# CITY PLANNING COMMISSION

**APPLICATION:** A. Negative Declaration

- B. Special Permit to develop a 420 student elementary school and parking lot on 6.7 vacant acres in the Single Family (R-1) zone

**PROPOSAL:** The applicant is requesting the necessary entitlement to construct the Greenmont Elementary School.

PROPOSED SITE PLAN - GREENMONT SCHOOL

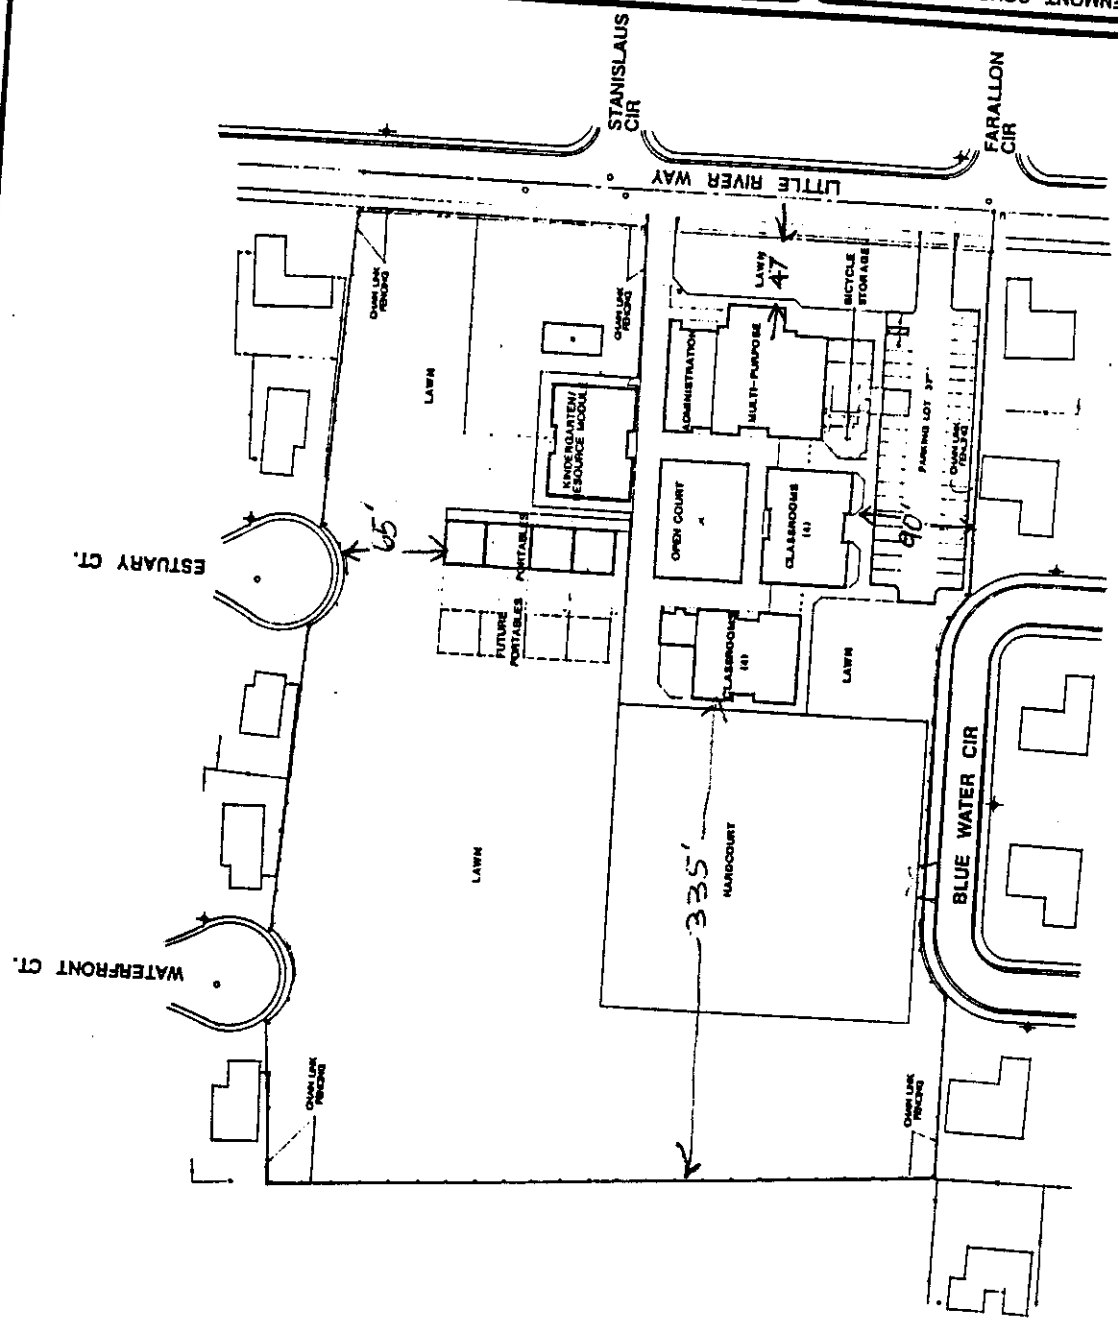
Staff met with the school district and their architect to review the plans with the following comments to be incorporated into the revised site plan (refer to Exhibit A, staff modified site plan).

The six foot chainlink fencing adjacent to Little River Way is to be set back 25 feet from the right-of-way. The area between the sidewalk and fence is to be landscaped. The applicant agreed to installing green vinyl-coated chainlink fencing where visible from the public right-of-way in place of the galvanized chainlink fencing.

Gates are to be provided at the ends of Waterfront and Estuary Courts to allow pedestrians onto the school grounds. A second gate will be proposed of Blue Water Circle near the south end of the parking lot.

The parking lot will be required to meet the City Tree Shading Ordinance requirement of 50% shading within 15 years of landscaping. A revised landscape plan should also show landscaping on the lot to assist in screening the single family dwellings.

The parking lot will abut existing single dwellings. The applicant has agreed to install a six foot high solid decorative masonry wall adjacent to the parking lot along the east property line. The wall shall not exceed the maximum height limits in the front yard setbacks.

All lighting shall be directed on-site and not reflect onto adjacent residential uses. The applicant's plans do not show lighting.

Due to security and surveillance necessary at an elementary school, the dumpster area will be a chainlink fence enclosed area through which adults can oversee children if they wander into the area. Staff suggested wrought iron but, due to cost, the applicant did not agree with staff. Staff recommends that a minimum of a five inch aggregate base rock and six inch Portland cement paving be used for the pad and apron.

Electrical transformers and gas distribution facilities will be located at the east side of the multi-purpose building near the bicycle storage area. They will be enclosed with chainlink fencing but not screened by landscaping. Staff recommends landscape screening of the bicycle storage and utility meter area.

The applicant's plans show a fence separating the park to the south from the school. The applicant does not plan on constructing the fence. The school is an "Open" Campus. The Community Services District has an agreement with the school district to have joint use of playing areas.

The setback for a fence exceeding three feet in height is five feet back from the street side property line. Staff has observed fences being set back for other schools with trees and landscaping along the public street right-of-way. Staff recommends that the fence be located a minimum of 10 feet from the property line with lawn, groundcover and trees planted on 20 foot centers along Blue Water Circle.

1. Driveway conflicts with legal crosswalk at Farallon Circle. it must be changed to line up directly or move completely away from the intersection.
2. Access to the "hardcourt" must not be via Blue Water Circle. The hardcourt often is used for special event overflow parking, therefore access must be via Little River Way which is wide enough to handle the traffic.
